UNITED STATES PATENT AND TRADEMARK OFFICE

Office Action Summary	Application No. 10/575,052	Applicant(s) LAMBERT ET AL.	
	Examiner JUSTIN JONAITIS	Art Unit 3752

DETAILED ACTION

U.S. Patent #1,952,816 to Mock: Figure 3

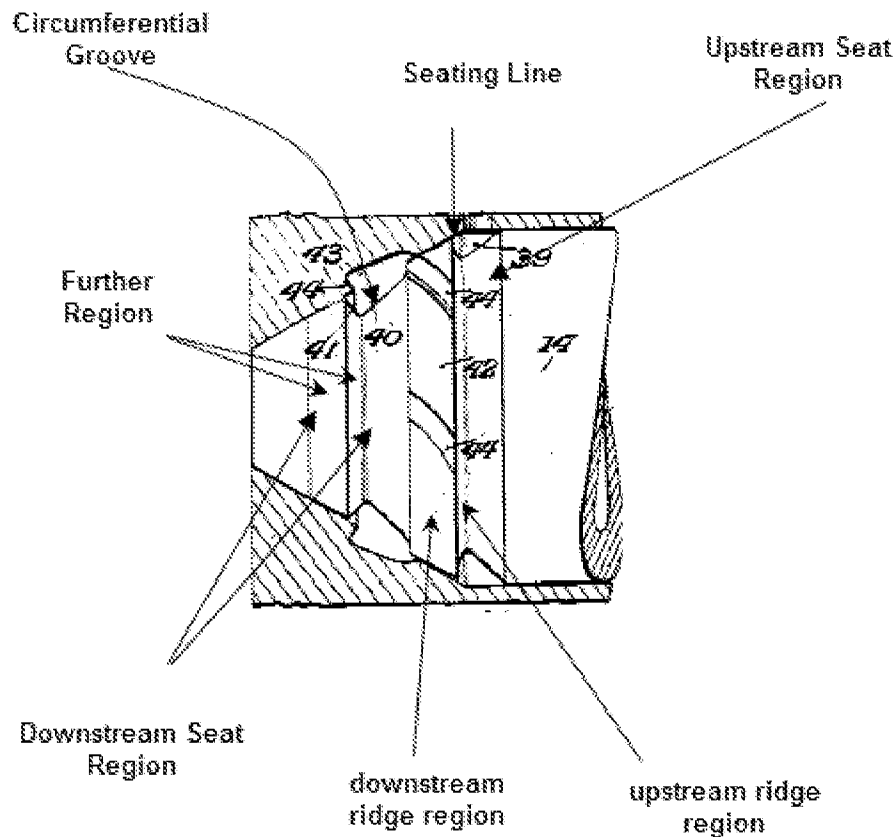
The figure below is reproduced from the Mock Figure 3 reference in order to show examiner's interpretation.

Mock discloses an injection nozzle for an internal combustion engine which is a valve covering orifice type injector, the injection nozzle comprising: a nozzle body (casing member (6)) provided with a bore (bore (10)) defining a valve seating surface (conical valve seat (11)), a valve member (valve (14)) which is moveable within the bore, wherein the valve member includes an upstream seat region (See Figure above) defining an upstream cone angle, where the upstream cone angle and the seat cone angle define an upstream differential angle, and a downstream seat region (See Figure above) defining a downstream cone angle, the downstream cone angle and the seat cone angle together defining a downstream differential angle, the valve member further comprising an annular ridge (See Figure above, downstream ridge region and upstream ridge region) protruding from the upstream and downstream seat region being disposed immediately downstream of the upstream seat region, wherein the protruding annular ridge defines a seating line (See Figure above) having a seat diameter, the seating line and being engageable with the valve seating surface to control fuel injection from the nozzle body. The protruding annular ridge includes an upstream and downstream ridge region (See Figure above) where the seating line is defined at an intersection between the upstream and downstream ridge regions.

The valve member disclosed by mock further includes a circumferential groove (See Figure above) arranged downstream of the downstream ridge region and immediately upstream of the further region (the end portion of the downstream seat region), wherein a lower edge of the circumferential groove and the further region define an intersection which defines, together with the seating surface a radial clearance that is sufficiently small so that a lower portion of the downstream ridge region defines a load bearing surface for the valve member.

7. Examiner agrees with applicant's interpretation of figure 3, however does not agree that the claimed limitations have not been met by the invention described by Mock. The zoomed in view of Figure 3 clearly shows that the angle of the bore in the casing is wider than the cone angle of the conical shoulder, as seen in the magnified view of figure 3 provided by applicant, however in the same figure it can be seen that the angles converge downstream of the gap creating a seat region. Therefore since the downstream region of the shoulder and the casing are in contact the limitations of an upstream seat region have been met.

9. Examiner disagrees. Applicant has not claimed that the upstream seating region must shut off the flow of fuel. Applicant has merely claimed that the valve member has an upstream seat region. Because mock shows a region upstream from the tip of the needle that sits against the casing (6) this limitation is fulfilled. Further applicant acknowledges in the remarks and arguments that on page 2, lines 131-137 of mock, "the frusto-conical shoulder (42) is preferably provided with spiral slots or grooves (44) on its periphery for increasing the area on which pressure may act to move valve (14)..." It's unclear how this structure does not assist in controlling fuel injection from the nozzle body as it clearly aids in allowing the valve needle to move.

12. The emphasized portions of the text show that the clearance (46) is a strictly present in the embodiment illustrated by figure 4 and was incorporated (along with the features of figure 3) into the embodiment illustrated in figure 5. This further provides evidence that the embodiment in figure 3 does not have a clearance between the casing and the frusto-conical shoulder.
